CARVER

Model C-4000

Sonic Holography/Autocorrelation Preamplifier

Service Manual

INSUFFICIENT RECIRC:

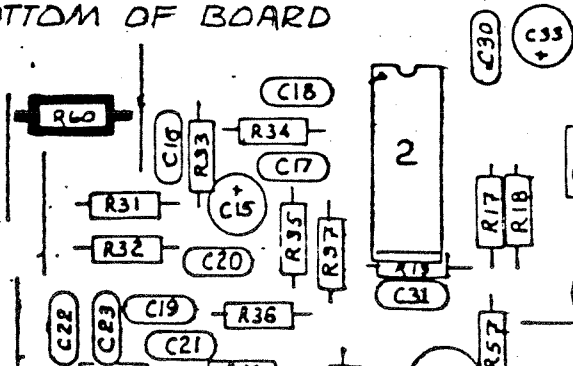
1. CHANGE R60 [9.1K] TO 6.8KΩ. VERIFY AUDIBLE ECHO RECIRC. BUT NO HOWL AT FULL-CLOCKWISE ROTATION OF ECHO DENSITY POT.
2. IF HOWL PERSISTS, GO TO NEXT-LOWER RESISTOR VALUE [6.2K, 5.6K] UNTIL HOWL CEASES AT FCW ECHO DENSITY.

1. CHANGE R60 [9.1K] TO 15KΩ. VERIFY AUDIBLE ECHO BUT NO HOWL AT FCW ECHO DENSITY.
2. IF ECHO REMAINS INADEQUATE, CHANGE R60 TO 30KΩ, OR REMOVE R60 AND LEAVE OFF PCB, IF NECESSARY.
3. IF HOWL OCCURS W/15KΩ, STEP VALUE DOWN UNTIL HOWL STOPS AT FCW ECHO DENSITY.

UPDATE

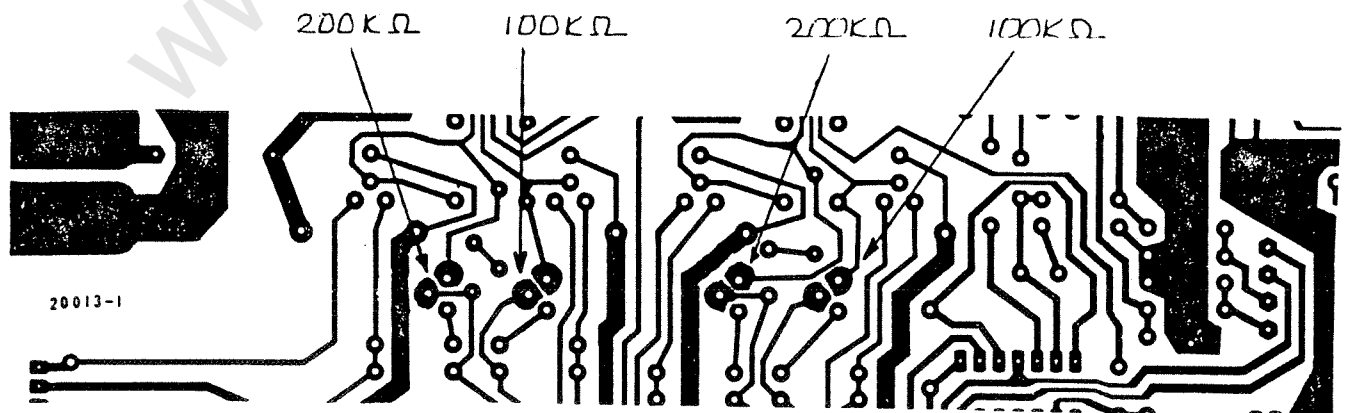
ADD 2 EA. 100KΩ AND 200KΩ RESISTORS TO PROVIDE LOCAL NEGATIVE FEEDBACK, STABILIZE PWR AMP AT LESS THAN FULL SUPPLY VOLTAGE.

1. REMOVE TOP AND BOTTOM COVERS.
2. PLACE UNIT ON ITS RIGHT SIDE W/ OPEN BOTTOM FACING YOU.
3. LOCATE FOIL SIDE OF PWR AMP PCB. BOARD MOUNTED BEHIND VOLUME AND BALANCE KTS.
4. LOCATE FOIL PADS OF PREDRIVER TRANSISTORS SHOWN BELOW.
5. TACK-SOLDER RESISTORS TO PADS SHOWN BELOW WITH LARGE CIRCLES.
6. REPLACE BOTTOM, REMOUNT 3 PCB'S BY THEIR RESPECTIVE ANGLE-BRACKETS, REPLACE TOP.

REPLACE DETHUMP FETs.

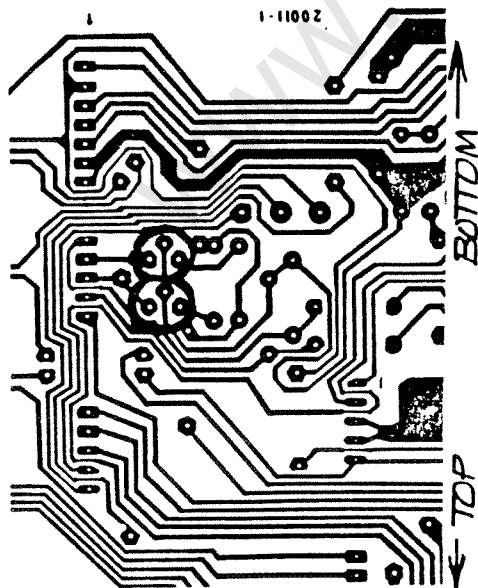
ONE FET PER CHANNEL IS USED TO "DE-THUMP", OR MUTE TURN-ON AND TURN-OFF THUMPS IN THE C-4000.

A SHORTED JUNCTION IN THE FET WILL PUT AS MUCH AS 1 VOLT OF DC ON THE OUTPUT OF THAT CHANNEL. THE USER SYMPTOMS ARE:

1. REMOVE TOP-COVER.
2. REMOVE CORRELATOR CIRCUIT CARD (THIRD FROM LEFT).
3. IDENTIFY AND LOCATE FOIL PADS OF DETHUMP FETs:

4. USE WICK TO REMOVE SOLDER.
5. PUSH FET LEADS THROUGH BOARD.
6. TILT UNIT UP AND RECOVER BOTH FETs BEFORE PROCEEDING.
7. INSTALL NEW FETs AS SHOWN:

8. REPLACE CORRELATOR BOARD. MAKE SURE NOT TO MOUNT IT ONE PIN OFF.

9. REPLACE TOP. TEST FOR DC ON OUTPUT OF C-4000.

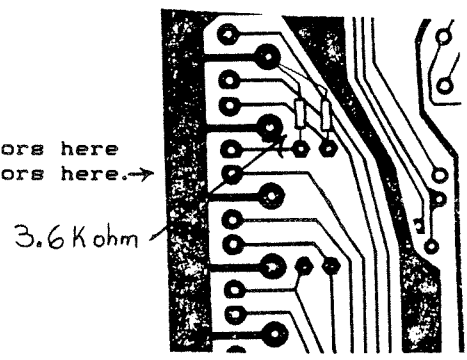
NOISE OR HUM PROBLEMS, WITH VOLUME DOWN, may be alleviated by reducing the output level of the C-4000. To accomplish this, and reduce the level at Main Output (upper) while leaving Main Output (lower) unaffected, follow this modification procedure:

1. Remove top cover.
2. Locate Phono board (center of unit, main input/output jack buss mounted to rear side of this board. Selector switch also mounts onto this board.
3. Locate two jumper wires which conduct signal from lower to upper Main Outputs, near back of board (see illustration below).
4. Remove these jumpers.
5. Install 6.8k ohm $\frac{1}{4}$ watt resistors in their place,
6. Install 3.6 Kohm $\frac{1}{4}$ watt resistors as shown below, on the foil side of the board, between signal out and ground.
7. Replace top cover.

The upper set of Main Outputs will now have about 10 dB lower output level.

NOTE:
For a 6dB reduction in output level, use 4.3k ohm resistors here and 5.6k ohm resistors here.→
